## 2009 Corvette Z06 and ZR1: GM TechLink Article: Oil System Changes - LS7 and LS9

Changes have been made to the dry-sump engine oil system used in the 2009 Corvette

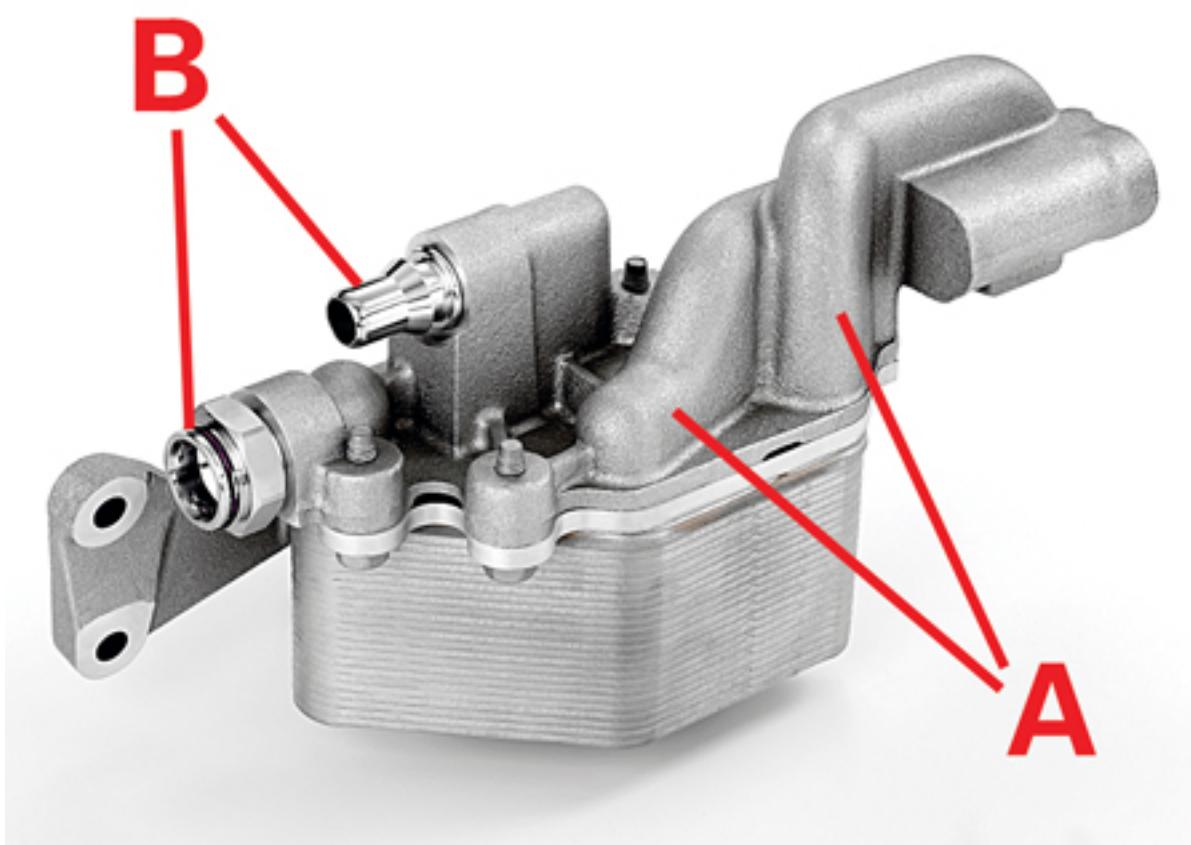
The dry sump system uses a dual gerotor oil pump, one rotor for scavenge and one rotor for supply (fig. 2) . The pump used on the LS9 produces greater volume and higher system oil pressure to provide adequate oil delivery under all conditions.

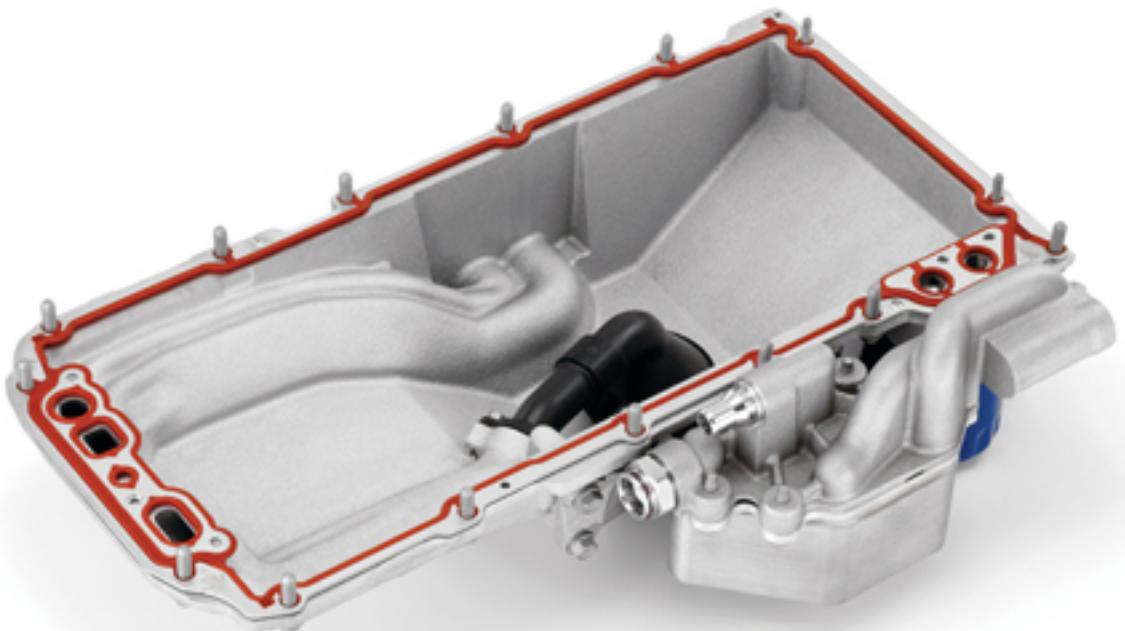
Both LS7 and LS9 use basically the same oil pan (fig. 4) . On the 2006-09

LS7, oil is  
routed from the pan to an external engine oil cooler located in front of the  
coolant radiator. The 2009 LS9 uses the same pan with a different design oil  
cooler that is mounted on the left side of oil pan (fig. 5) .

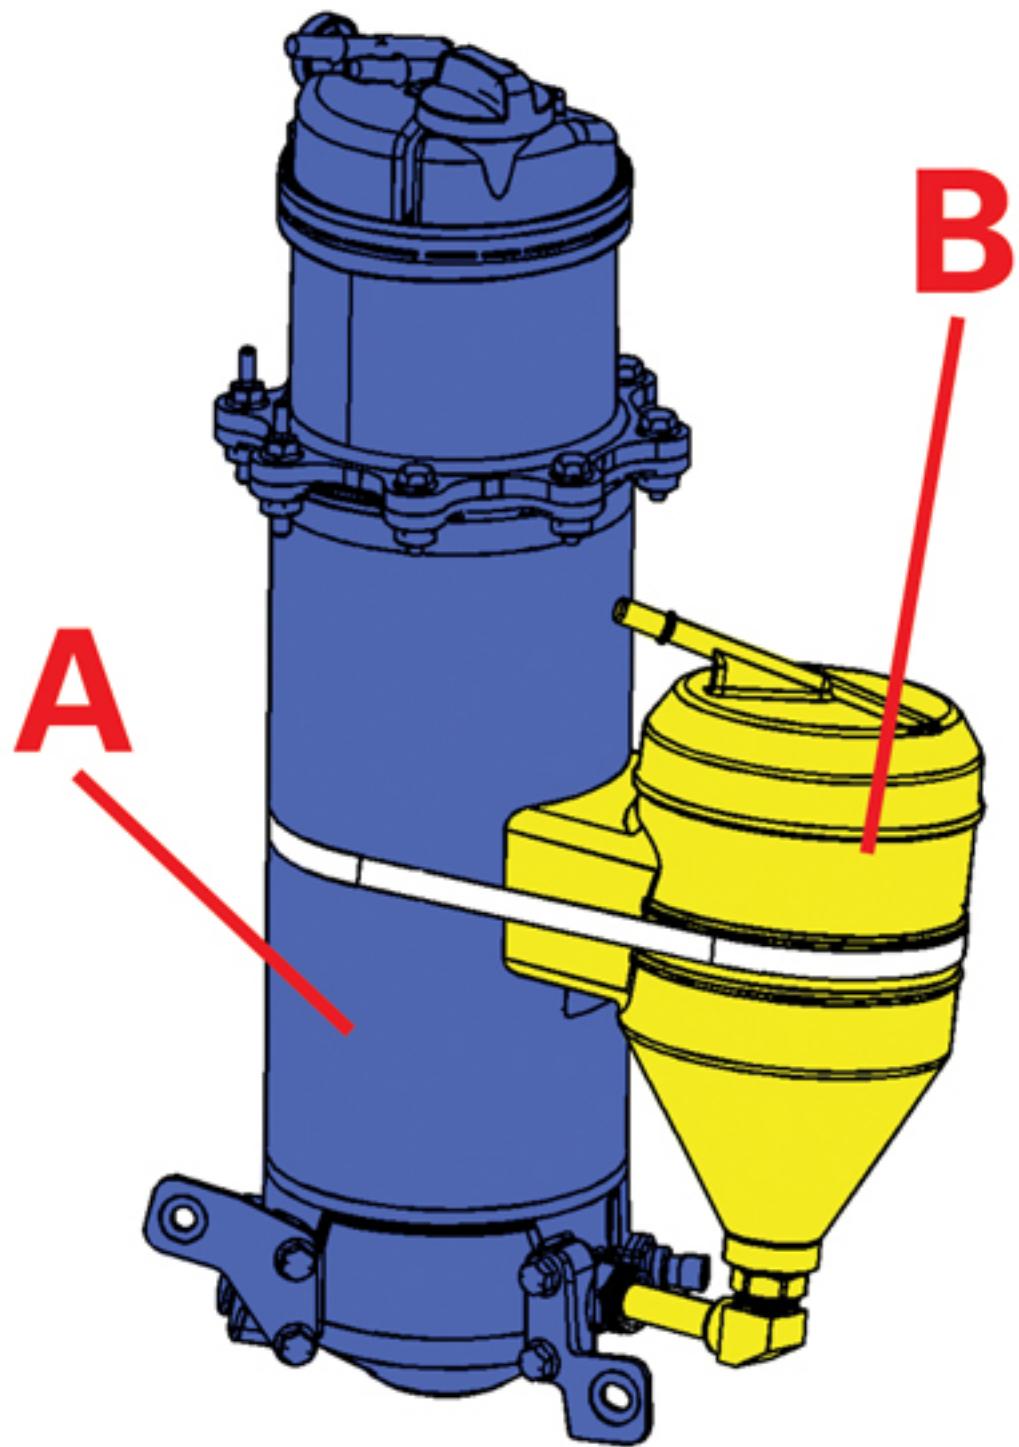
For both engines, the oil reservoir has been redesigned to increase the oil capacity of the system. Under extreme cornering loads such as experienced on a banked race track, extra oil capacity ensures that there is sufficient oil in the reservoir to avoid the ingesting of air due to slosh. A second tank is connected to the main tank by tubing (fig. 6) .

A Original reservoir

B Added capacity
